P-10855

Re: Report No. 2
FERC Independent Consultants Review Panel
Silver Lake Dam

REPORT NO. 2
FERC INDEPENDENT CONSULTANTS REVIEW PANEL
SILVER LAKE DAM

TECHNICAL REASONS FOR THE RELEASE OF
SILVER LAKE RESERVOIR ON
MAY 14-15, 2003

Figure 2.3.1-1 Fuse plug and channel plan and profile

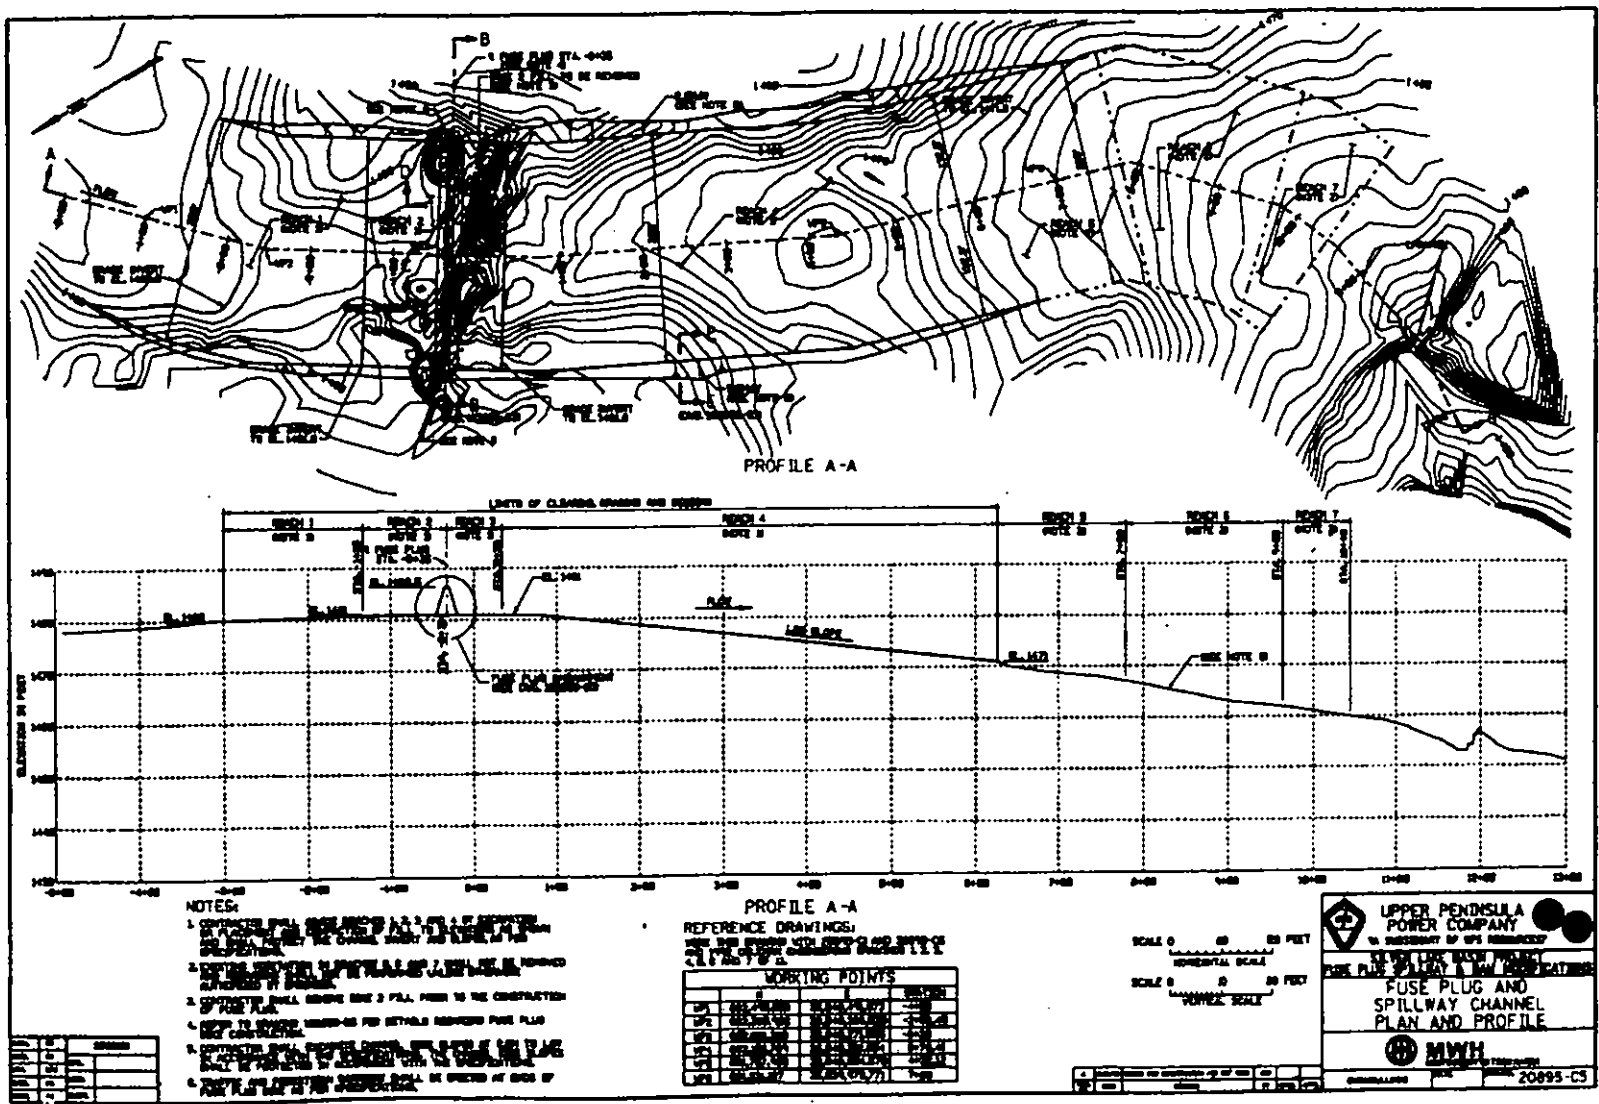
The widths of the inlet and outlet channels were the same as the length of the fuse plug embankment — 265 ft (80.8 m). For about 100 ft (30.5 m) upstream and downstream from the fuse plug embankment, the inverts of both channels were level, at elevation 1481.0. From a point 100 ft (30.5 m) upstream from the center of the embankment to a point about 265 ft (80.8 m) upstream, the inlet channel was graded to slope downwards at about 0.7 percent in an upstream direction, and followed the natural grade further upstream, as shown by the profile in Figure 2.3.1-1. From a point about 100 ft (30.5 m) downstream from the center of the fuse plug embankment to a point about 660 ft (201.3 m) downstream, the outlet channel was graded to slope downstream at 1.8 percent, and followed the natural grade further downstream, as shown by the profile in Figure 2.3.1-1.

The report ignores the velocities along the outlet channel which, after a horizontal reach about 100 ft (30.5 m) long, slopes downstream at 1.8% slope for about 540 ft (165 m). The higher velocities in that portion of the channel can be inferred from Figure 8 of the Design Report "Profile Along the Emergency Spillway Channel". The flow depth at PMF conditions, which is about 8.0 ft (2.44 m) at the channel entrance, is reduced to 5 ft (1.5 m) along the 1.8% slope channel. The corresponding flow velocity is about 14.5 fps (4.4 m/s), far above the permissible velocities for grassed channels.

Figure 2.3.1-2 Fuse plug cross sections

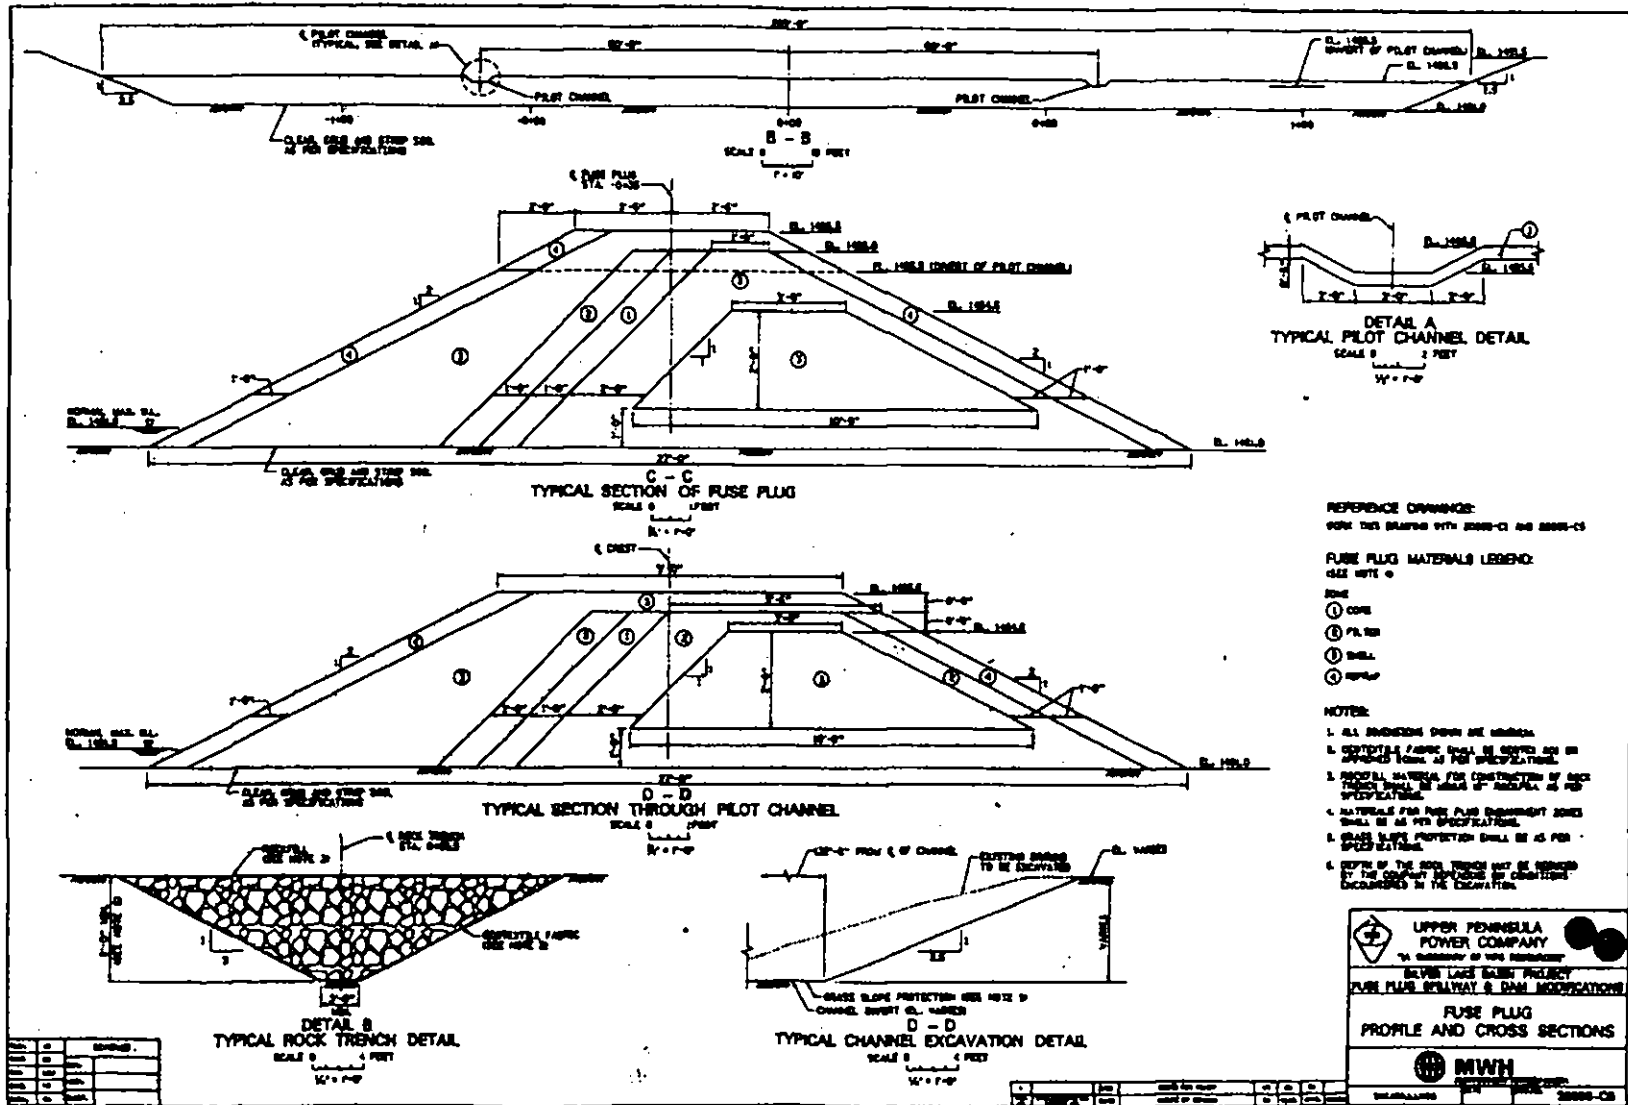
The design included an 8 ft (2.4 m) deep rock trench, with its centerline about 100 ft (30.5 m) downstream from the centerline of the fuse plug embankment, to impede headward erosion of the outlet channel closer to the fuse plug embankment. The cross section through the rock trench is shown in Figure 2.3.1-2.

As shown in Figure 2.3.1-2, the fuse plug embankment was constructed with four zones – Core, Filter, Shell, and Riprap. The gradations and Unified Soil Classification System classifications of these materials are given in Table 2.3.1-1.

In the original MWH design, a Rock Trench was included as shown in Figure 2.3.1-2. The Rock Trench was 8 ft (2.4 m) deep and 3 ft (0.9 m) wide at the bottom with side slopes of 1V to 2H. Although this structure may have slowed the erosion, it is most likely that it would have been undermined from the downstream side. Because the trench was founded on erodible materials, due to its shallow depth of penetration (8 ft) (2.4 m) it most likely would have sunken down slowly as it was undermined from the downstream side. It is our understanding, from documents reviewed, that FERC agreed with the removal of this feature from the original design at the request of MWH.

Figure 2.3.2-5

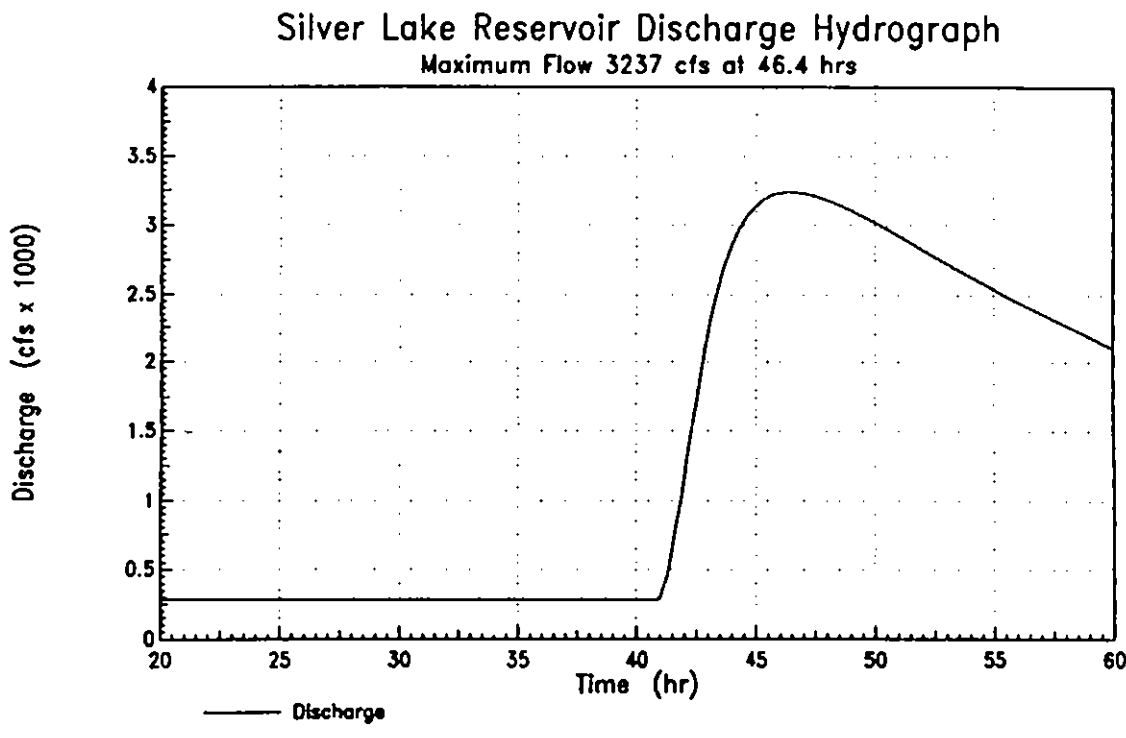
The maximum discharge for this case (Figure 2.3.2-5) is only 3237 cfs (92 m³/s) as compared to the 20,000 cfs (568 m³/s) discharge in the selected fuse plug design. Raising of all embankments to 1491.5 and operating the reservoir to 1481.5 as an initial condition would allow the PMF to be accommodated by use of the original spillway with no fuse plug construction. This concept has the advantage that the key elevations of all structures are equal to or higher than the "old" structures which have accommodated many significant floods since they were constructed in 1944, enhancing the safety for more frequent floods.

Figure 3.6.2-3 Water levels in Silver Lake before and after fuse plug breach

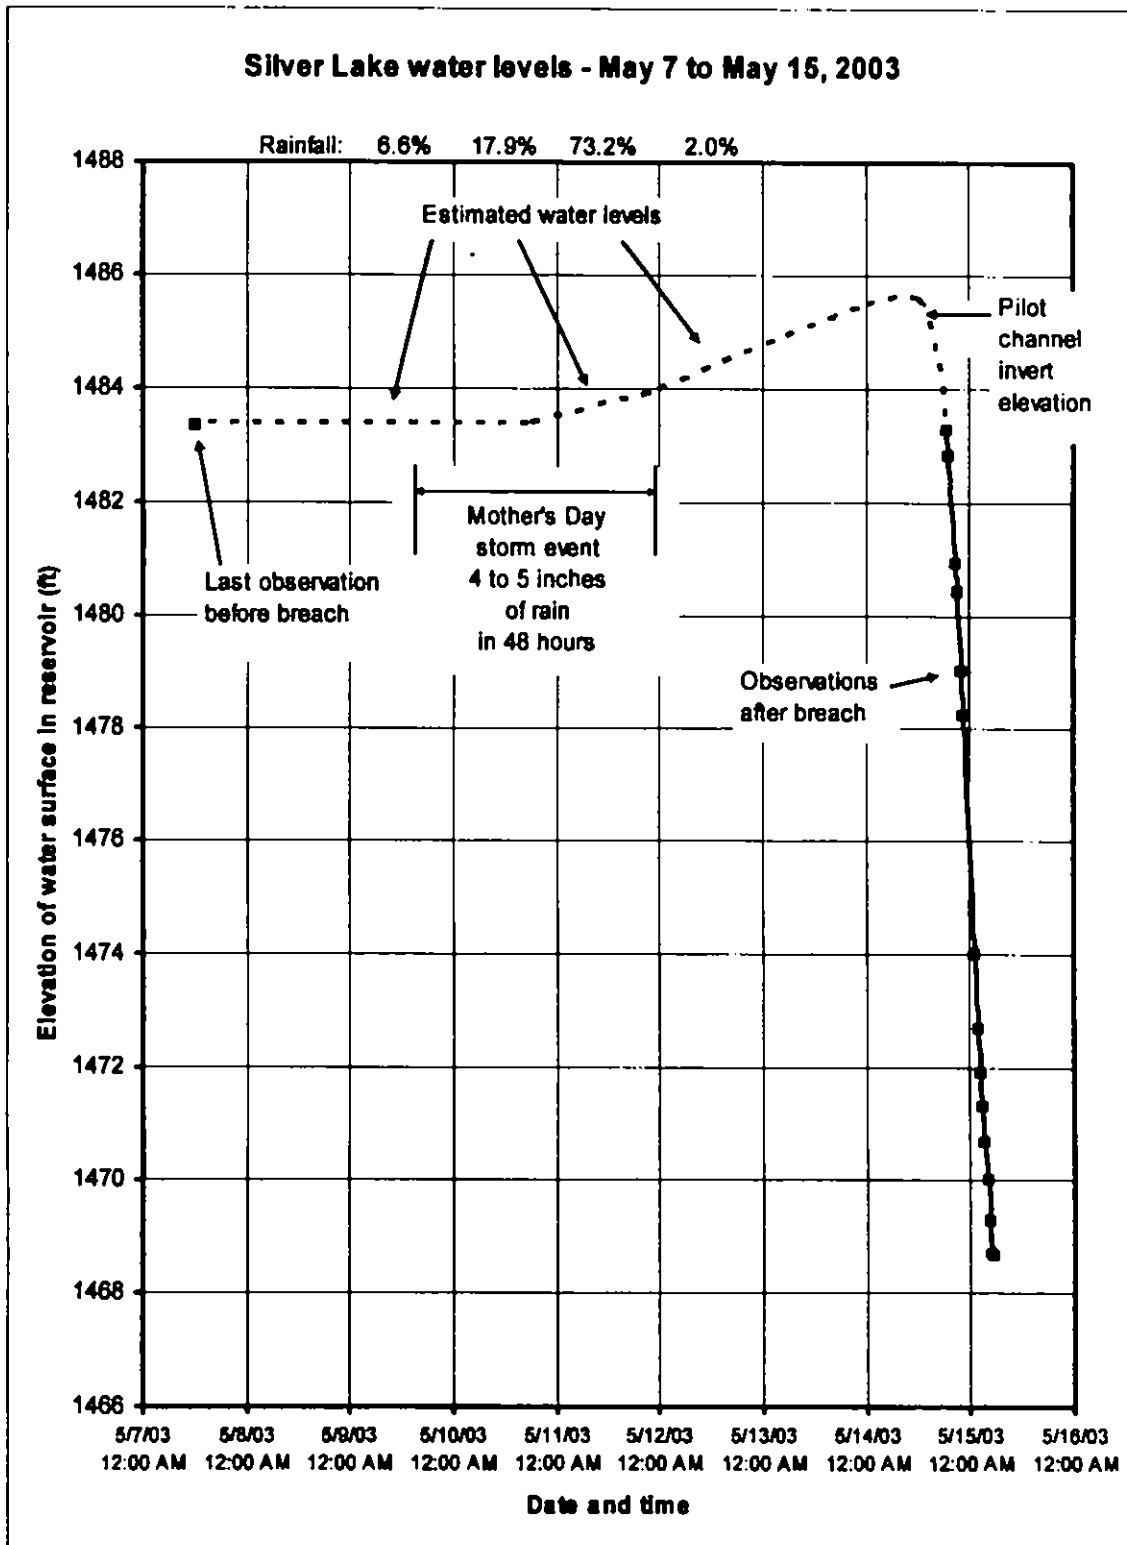
Although the maximum water level, and the time at which it was reached, cannot be determined with precision, the facts available have been used to develop the graph of estimated Silver Lake water levels from May 7 to May 15 shown in Figure 3.6.2-3. The estimated water levels between May 7 and May 14 are based on the assumptions that the lake level would be about constant until the Mother's Day storm event, and that the resulting inflow was the principal cause of the rise in lake level, and that the maximum lake level corresponds to the high water mark indicated by the debris trapped at the ends of the stop logs. While there is some uncertainty about the variation of water level with time

shown in Figure 3.6.2-3, the variation shown is consistent with the available information.

Figure 3.6.4-2 Cross section through eroded channel at STS Station 27+00, near fuse plug axis

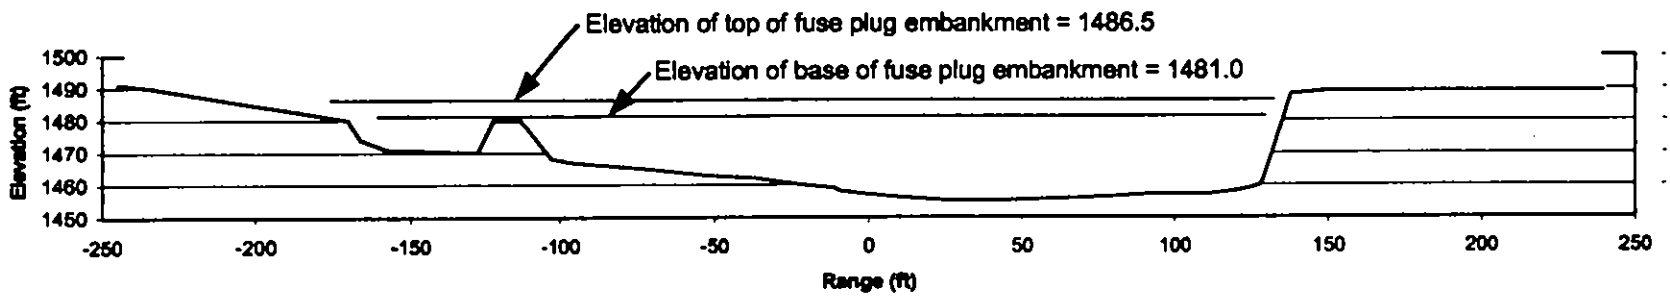
Figure 3.6.4-2 shows a cross section at STS station 27+00, approximately at the axis of the fuse plug embankment. The eroded channel is about 300 ft (91.5 m) wide, extending 130 ft (39.6 m) to the right of the STS stationing axis, and 170 ft (51.8 m) to the left. An un-eroded "island" about 120 ft (36.6 m) to the left of the station axis indicates that the course of erosion was governed to some extent by non-uniform resistance to backcutting as the eroded channel became progressively wider and deeper.

FIG. 7-3. U.S. and U.S.S.R. data on permissible velocities for noncohesive soils.

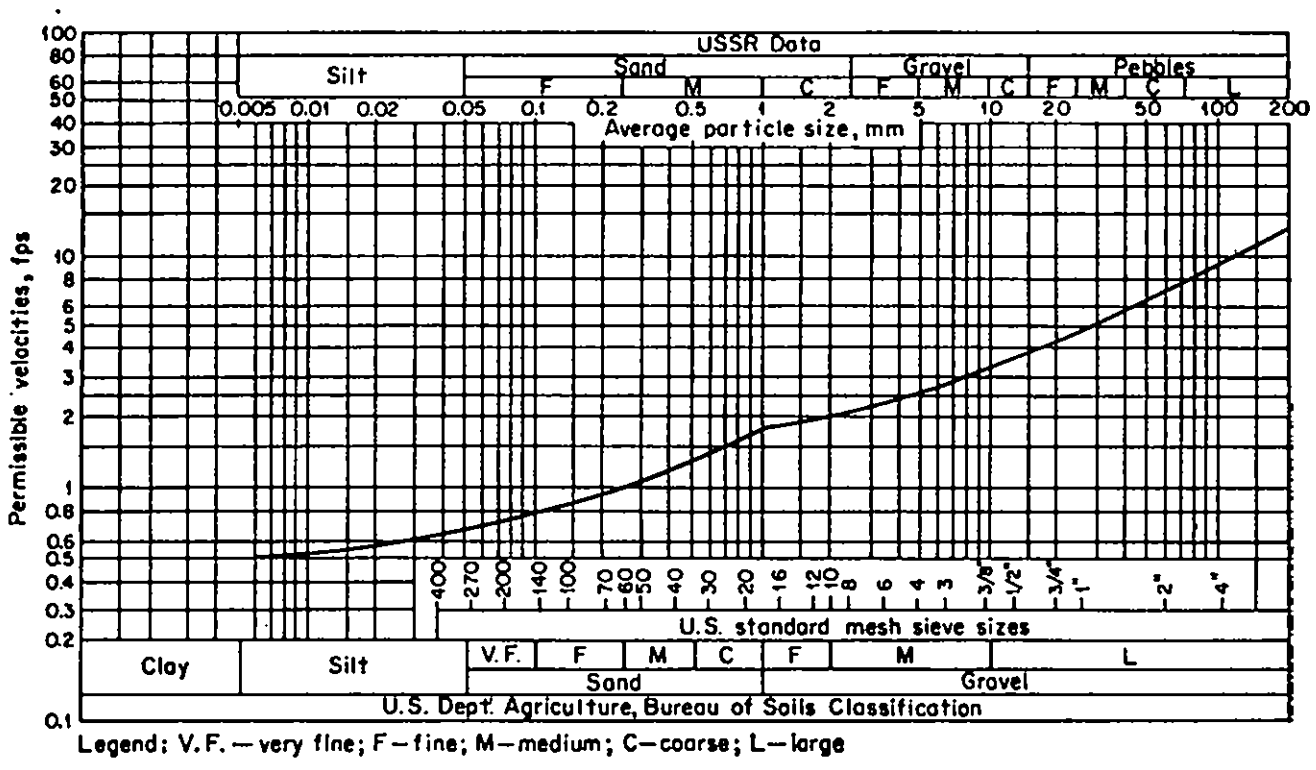
In 1936, Russian data was presented regarding permissible velocities for various sizes of cohesionless soils. This data is presented in Figure 7-3 of Chow and in Figure 4.4.2-3 of this report. As shown in Figure 4.4.2-3, the permissible velocity for fine sand is 0.75 fps (0.23 m/s) and for the material retained on the #4 sieve is 2.5 fps (0.76 m/s). Thus for coarse sand or fine gravel the limit of 2.5 fps (0.76 m/s) is the same as given in Figures 4.4.2-1 and 4.4.2-2.

From the grain size distribution of the foundation soils it is clear that the foundation soils are composed of silty fine sands (SM) and uniform fine to coarse sands (SP). For no channel treatment, the permissible velocity could probably not exceed 2.5 fps (0.76 m/s). Since it was not possible for grass to grow between the late fall of 2002 and May 14, 2003, the possible effect of grass in increasing the permissible velocity is a moot point. The pictures taken at the end of construction show a bare untreated foundation surface upstream and downstream of the fuse plug.
